# Highland Lakes Elementary Proposed BMP Improvements

Project: Highland Lakes ES Drive Lane Pond Improvements

We've prepared the following summary of LCRA Water Quality BMP Improvements that have been required for previous and current development on the Highland Lakes Elementary School Site. Note that current LCRA requirements significantly exceed BMP designs provided for previous development on the site. Refer to Attachments A-C for plans previously approved by LCRA. During review of the currently proposed site improvements, LCRA also required additional levels of design detail with direct cost implications. Refer to Attachments D-F for design progression through LCRA review. Refer to Attachment G for LCRA Comment Response Letters. Refer to Attachment H for Additional Required LCRA Permit Documentation. Some requests from LCRA, including an underdrain system in Pond 2, were waived through coordination during site review.

**Attachment G: LCRA Comment Response Letters**

LEGEND

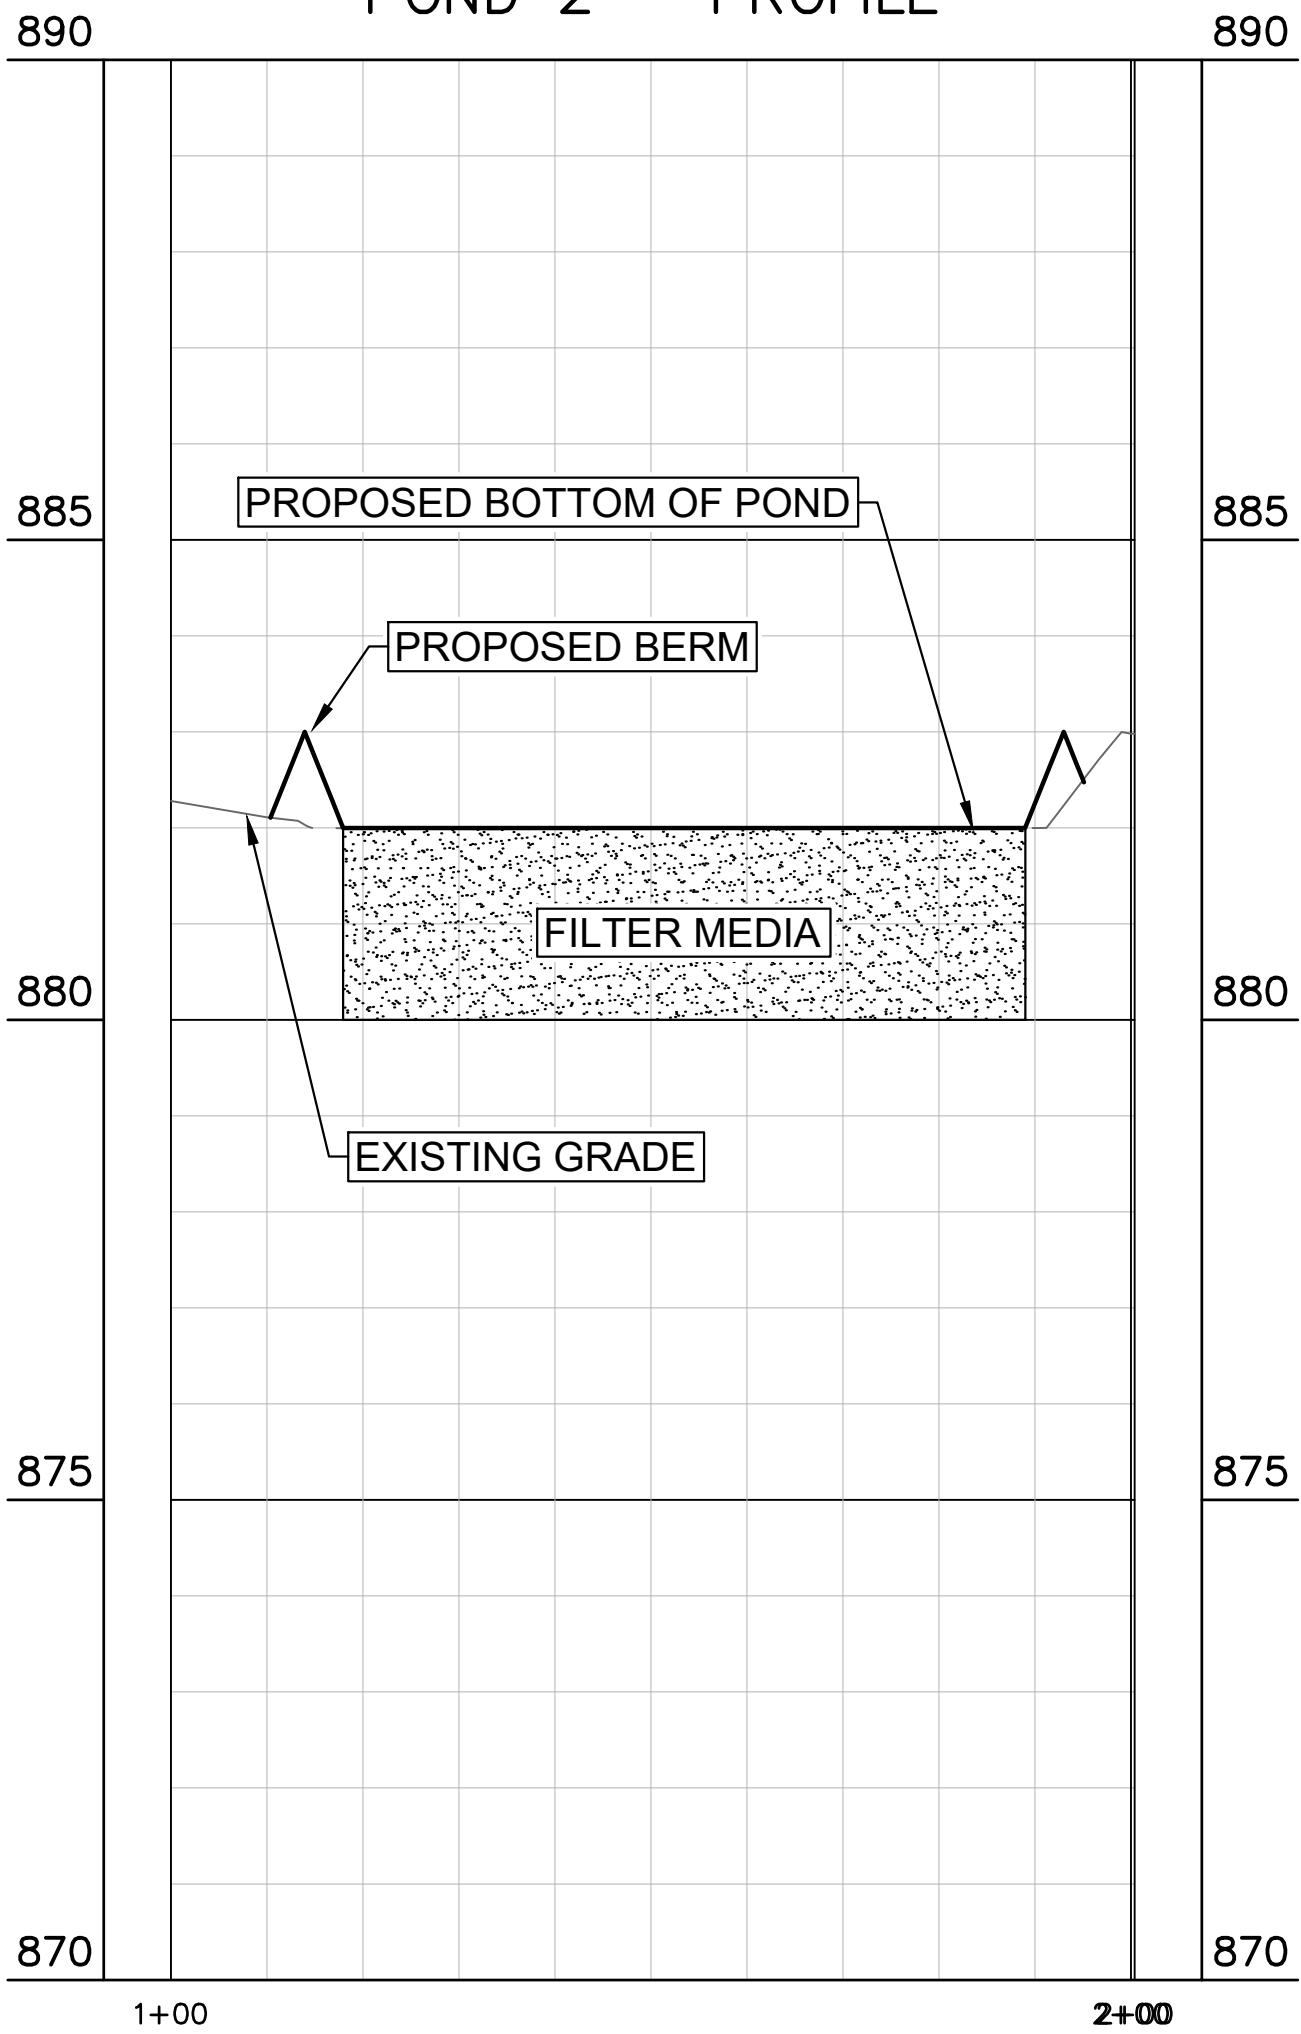
U2 – Comment partially addressed. Please adjust or provide the following for Pond 1:

1. Verify that all flowlines within the bioretention basin are at the same elevation.
2. Verify that all piping is perforated 6" SCH 40 PVC with 3/8" perforation and add FL callouts.

3. Provide cleanouts for all underdrains within the basin and provide a cleanout detail.
4. An orifice of 1" minimum diameter on the underdrain outfall is required. Please see sheet 172 for the requirement and sheet 177 of the HLWO technical manual to calculate the true orifice diameter. Please make sure to provide a callout specifying the orifice diameter and provide an orifice detail (threaded cap, etc.).

5. For the inner basin underdrain system please provide at least one cleanout above the WQV elevation.
6. Provide culvert discharge velocities used to calculate the riprap and add the riprap size to the call-out.

7. The top of the rock berm only needs to be at the WQV EL. Also, provide a rock berm detail or specify the following types of wire for the berm detail provided "metallic-coated or PVC-coated steel with a minimum wire size of 14 gauge (0.080 inch or 2.0 mm diameter)."

3. Cleanouts are provided at the start of each underdrain lateral. An LCRA detail is provided in the Water Quality Details & Notes plan sheet. Please confirm if this meets LCRA requirements.

4. The true orifice diameter was calculated through applying the formula on sheet 177 of the HLWO technical manual. These calculations, as well as, the equation, for reference, have been provided on Pond 1 Plan & Profile plan sheet. A threaded cap with 1.2" orifice is called out at the underdrain outlet.

6. The concrete channel discharge velocity, along with the rip-rap calculations for the flow entrance and outfall have been added to the Pond 1 Plan & Profile plan sheet. The rip-rap size has been added to the callouts.

7. The rock berm has been adjusted to be at the water quality elevation of 887.00'. The detail provided on Pond 1 Plan & Profile plan sheet shows the rock berm being 14" in height, with 2" being underground. A callout with the type of wire options to be used has also been added to the detail.

**POND 2 PLAN & PROFILE**

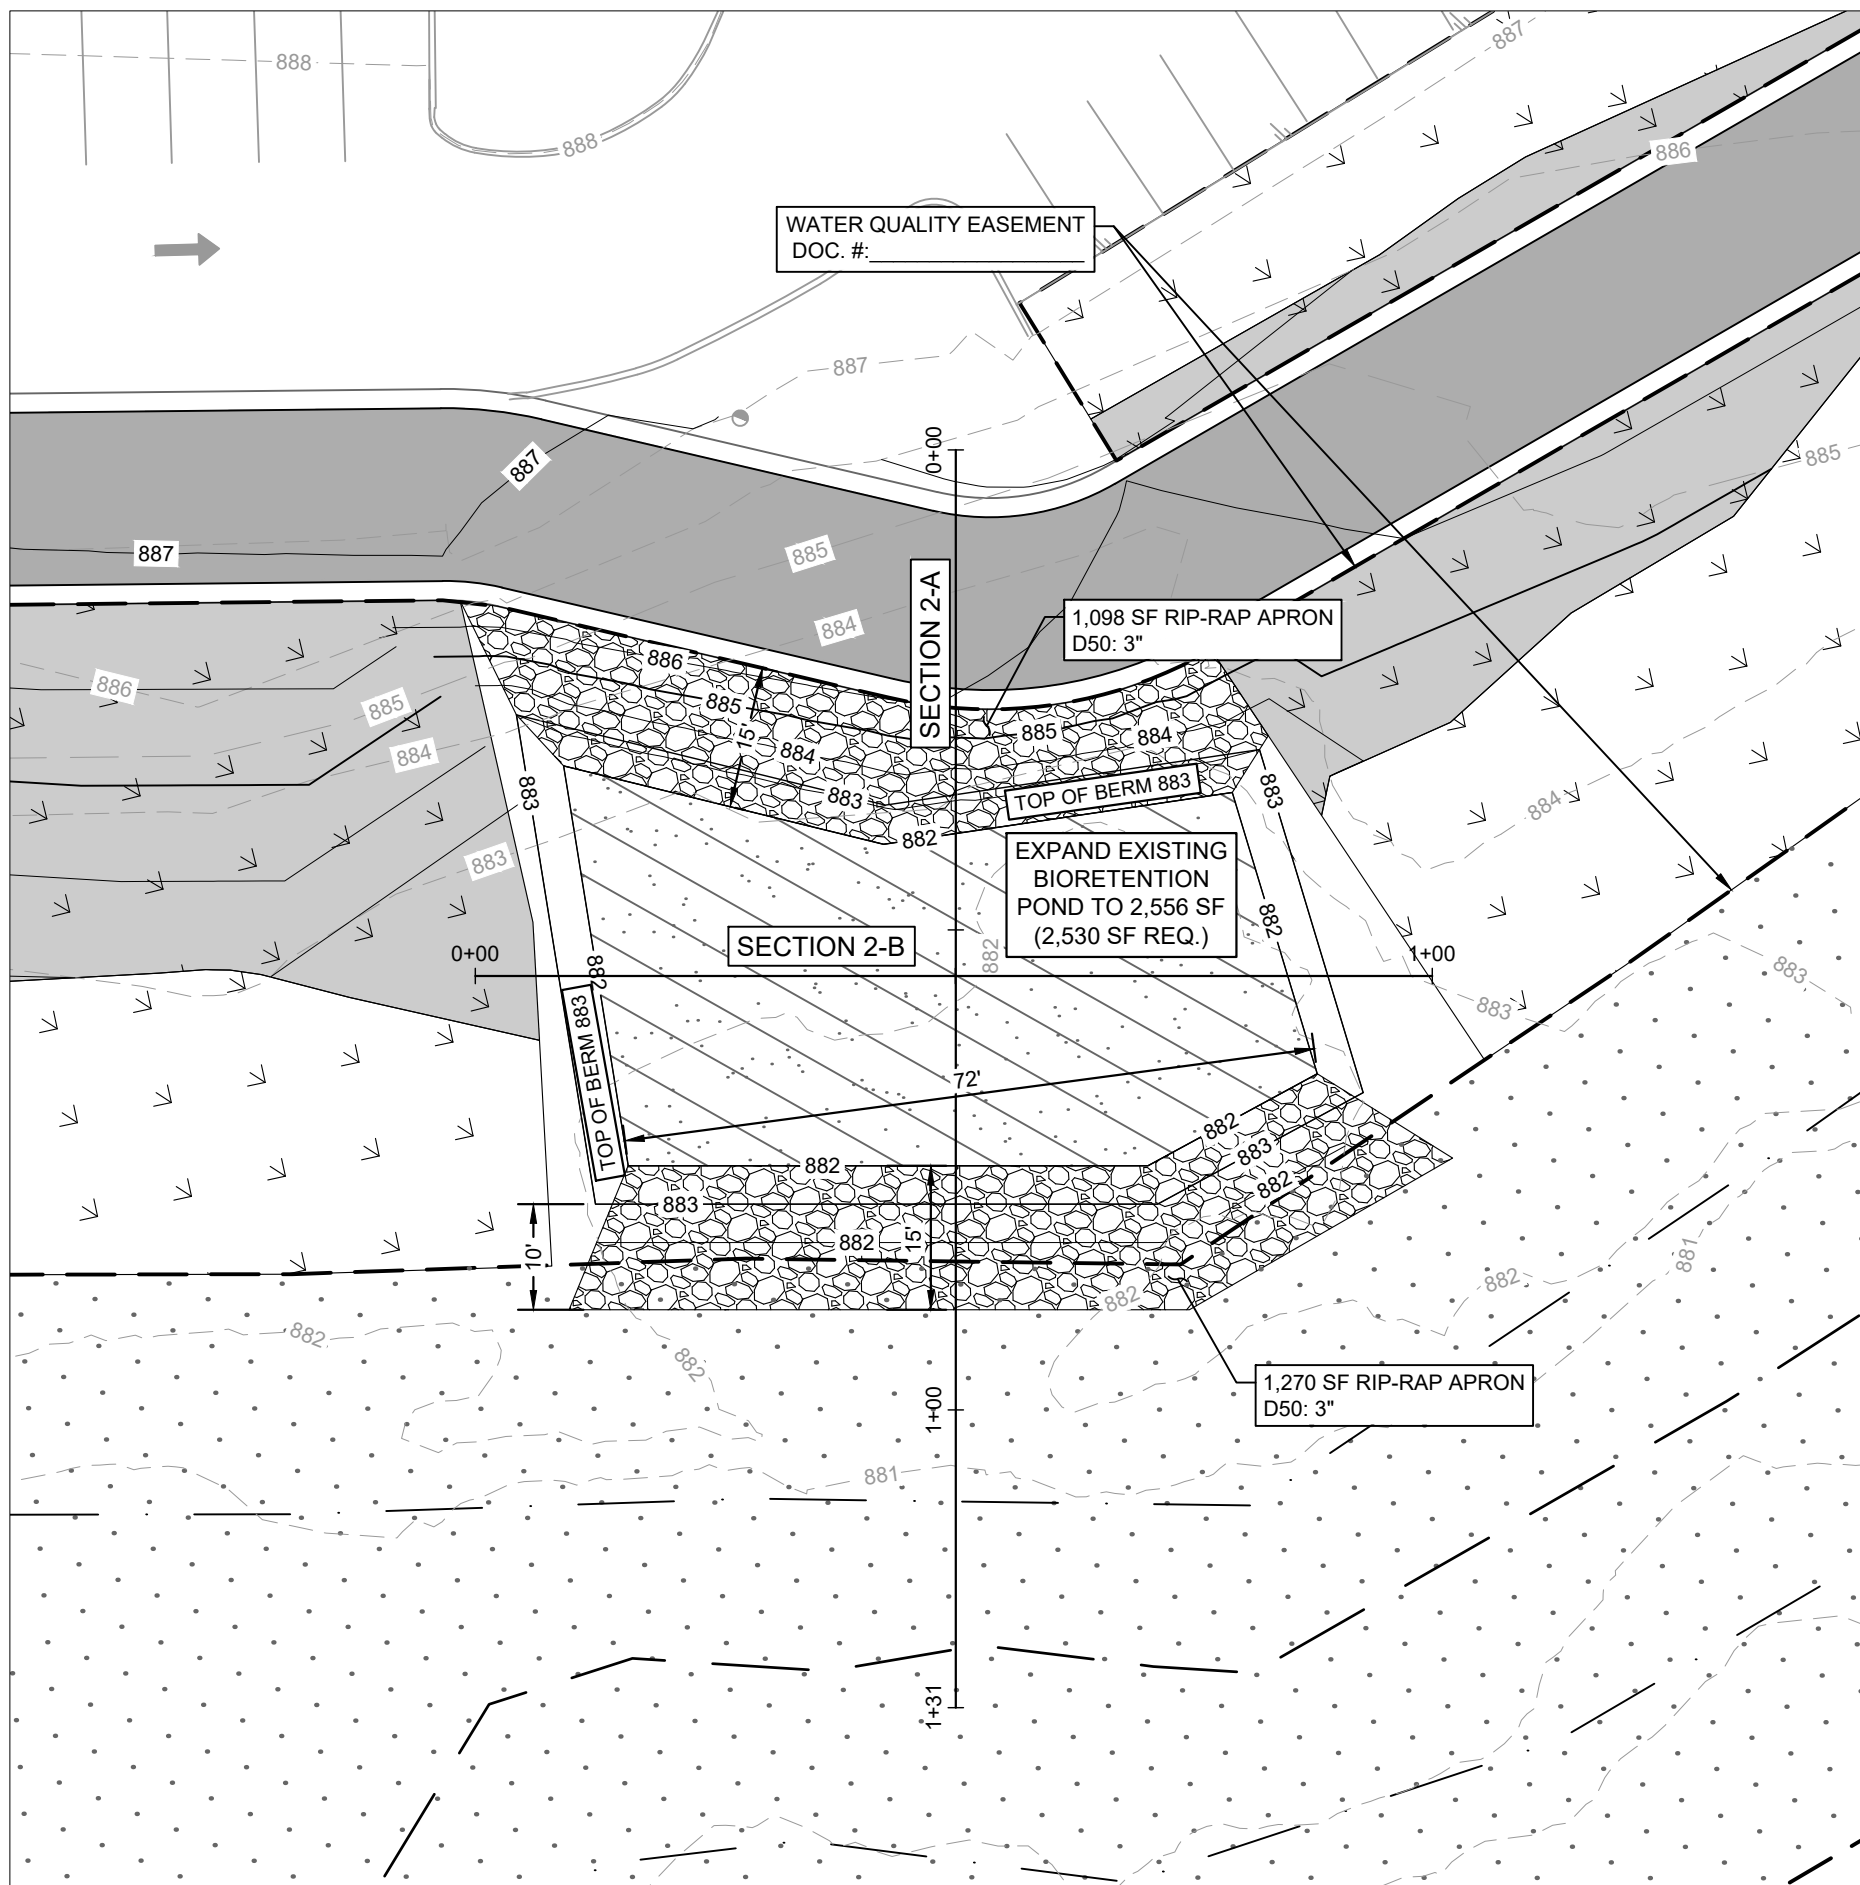
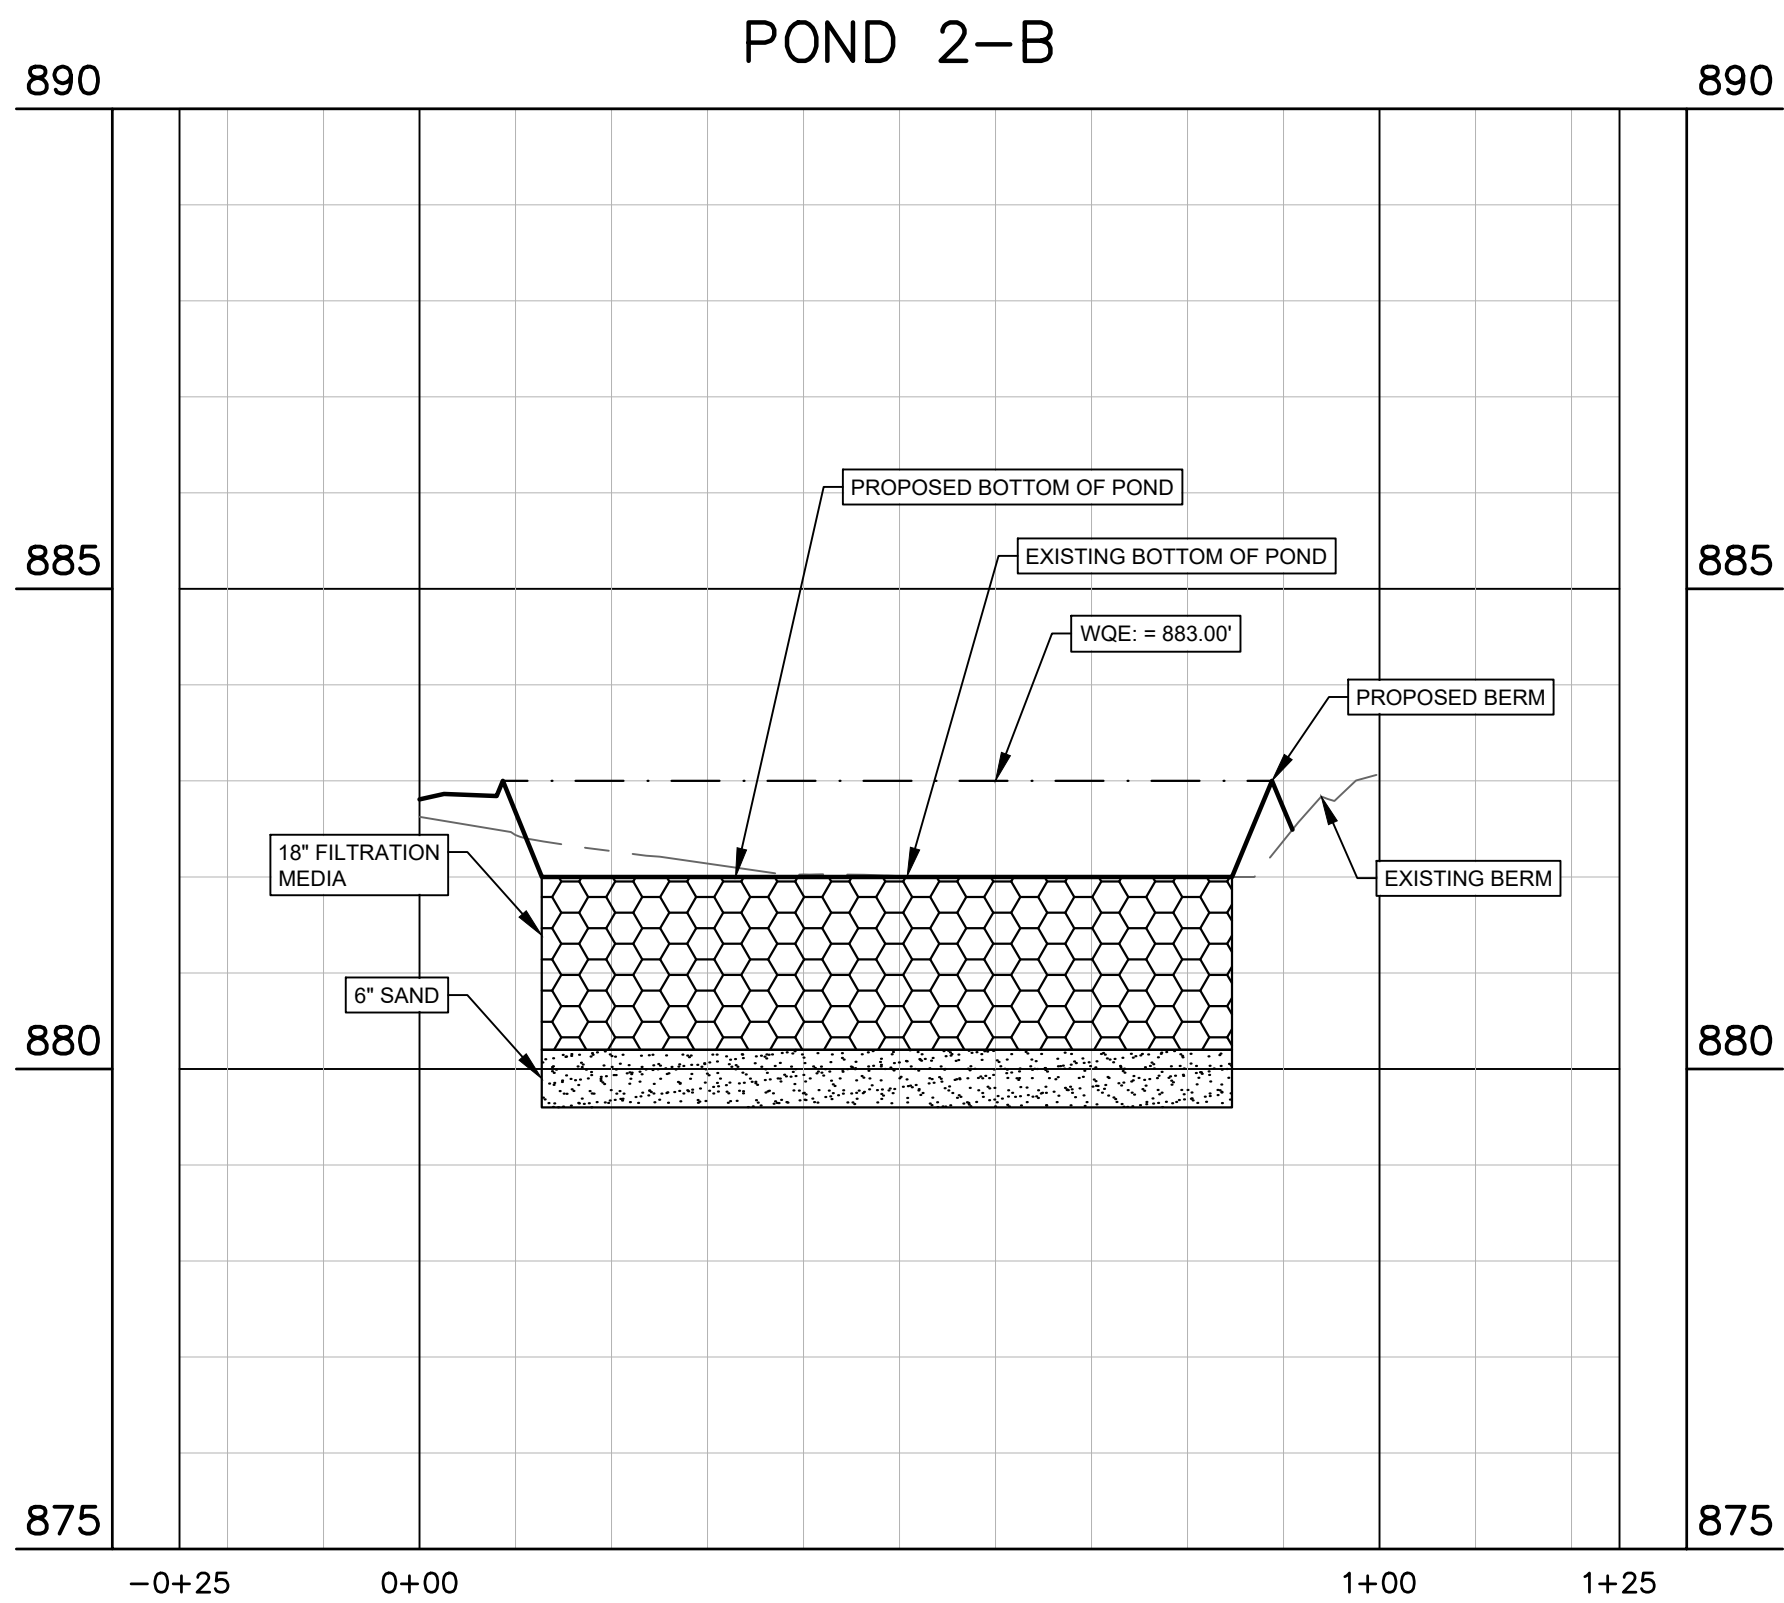
U2 – Comment partially addressed. Please adjust or provide the following for Pond 2:

8. Current slope on the upstream embankment is over 30% recommend adding riprap on embankment and sizing it to the 25-year flow event to avoid any scouring. Also, please provide calculations.
9. Provide discharge velocities used to size the downstream riprap apron. See comment #33-U1.

8. Rip-rap has been added all along the upper embankment of the pond, similarly to how it's shown on the downstream end. Calculations for the rip-rap sizing and apron length are provided on the Pond 2 Plan & Profile plan sheet. Peak flow and velocity for the 100-YR storm event was used in place of the 25-YR flow to provide the maximum Rip-Rap values needed.

9. The discharge velocity used to size the rip-rap downstream has been included within the rip-rap calculations table on the Pond 2 Plan & Profile plan sheet.
